**Re: Response to AOC 12 – Smith Creek & Detention Basin Comment Letter
(02/11/2022)
Hess Corporation Former Port Reading Complex (HC-PR)
750 Cliff Road
Woodbridge, Middlesex County, New Jersey
NJDEP PI# 006148
ISRA Case No. E20130449
EPA ID No. NJD045445483**

Earth Systems, Inc. (Earth Systems) has prepared this letter on behalf of Hess Corporation (Hess) regarding the February 11, 2022 comment letter and April 27, 2022 site visit regarding the July 30, 2021 AOC 12 – Smith Creek and Detention Basin Supplemental Remedial Investigation Workplan (RIW).

FIGURE: 1
AOC 12
Proposed Additional Sample Locations

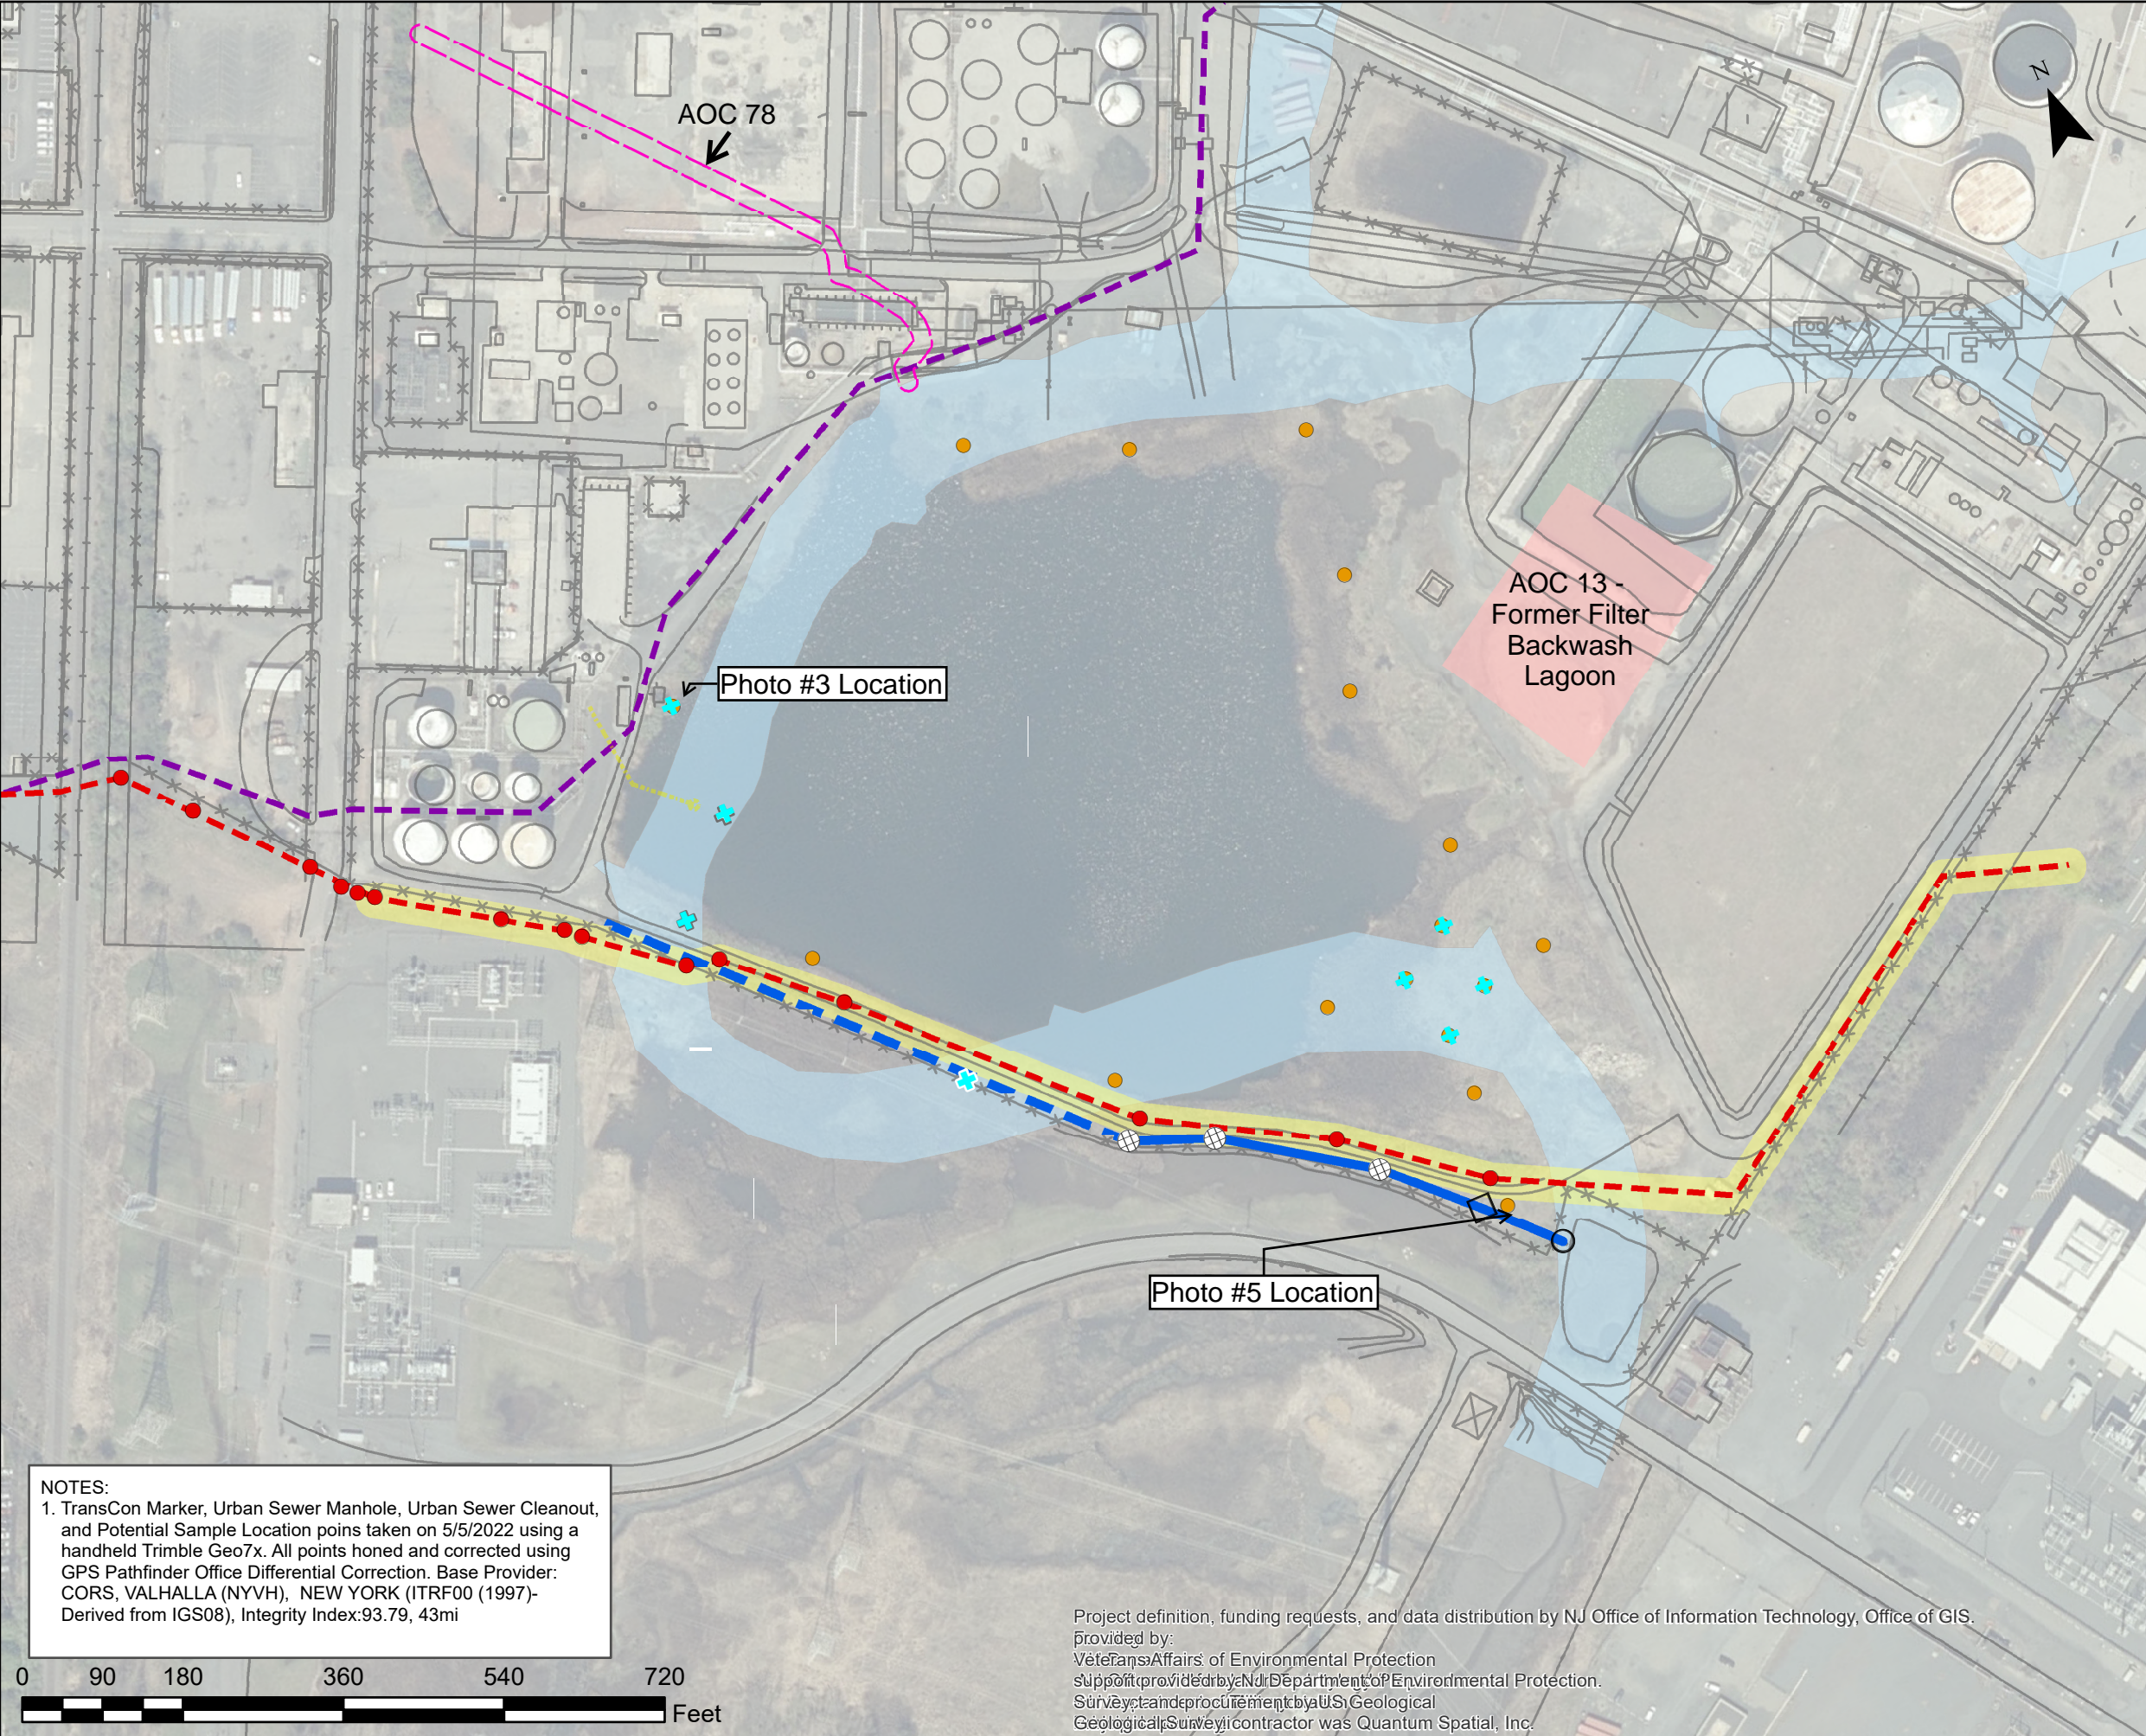
g. Appendix E – The Photo 3 location is needed on site figures (outfall along northwestern shoreline of Detention Basin)

h. Appendix E – The Photo 5 location is needed on site figures (southwestern portion of site outfall to urban sewer not connected to detention basin; “outfall leads to Smith Creek Pond”).

NJDEP Comment 16: Former Site Operations: The former filter backwash lagoon location on figures is not accurate based on aerial photos – the lagoon partially aligns with the TK-1911 basin.

NJDEP Comment 17: The Location of AOC 78 connection to the Detention Basin/Smith Creek needs to be shown:

NJDEP Comment 20: The historical location of Smith Creek, which previously was open water that was filled/alterd and became a marsh or a vegetated area (an ESNR), needs to be investigated. The Department recommends the following locations need to have additional samples taken.

1. The figure below displays the area south of the road. Please collect a minimum of two samples where the former Smith Creek used to be.

b. Please include a minimum of four additional samples in between the proposed sample locations. Please note the proposed samples are approximately 150 to 200 feet apart.

NJDEP Comment 26: The report did not indicate if samples were collected in the locations where photos No. #3 and #5 (appendix E) were taken. If sediment samples were not collected, then please take sediment samples at those locations, or provide adequate justification for not addressing an area potentially impacted by contaminants.

Earth System/Hess Response 8g – The location of Photo 3 is identified on **Figure 1** (attached). A photo location map will be included with the final RIR. In addition, an updated photo of the specified location will be included on a figure in the final RIR.

Earth System/Hess Response 8h - The location of Photo 5 is identified on **Figure 1** (attached). A photo location map will be included with the final RIR. In addition, an updated photo of the specified location will be included on a figure in the final RIR.

Earth Systems/Hess Response 16: Please see the attached **Figure 1** which depicts the former filter backwash lagoon in the location specified above.

Earth Systems/Hess Response 17: The location of AOC 78 has been included on the attached **Figure 1**.

Earth Systems/Hess Response 20: Additional samples have been proposed based on the above comments and discussions had during the April 27, 2022 site meeting. Please note that we have revised the location of the pipeline on the southern boundary of the Site. Also, as observed during the NJDEP's Site visit, the southern portion of the Site is a challenging area to collect samples due to the presence of pipelines, the urban sewer, and localized flooding. In addition, the adjacent off-site area owned by PSE&G is also a challenging area to collect samples from due to localized flooding, vegetation, pipelines, and overhead power lines.

We believe that the proposed sample locations depicted on the attached **Figure 1** will address the above NJDEP comments and will provide the necessary data from locations that are safe and accessible.

Earth Systems/Hess Response 26: A sample was proposed in the location of Photo #5 in the supplementary RIW. However, a sample was not proposed for Photo #3. An additional sample has been added to this location, see **Figure 1**.
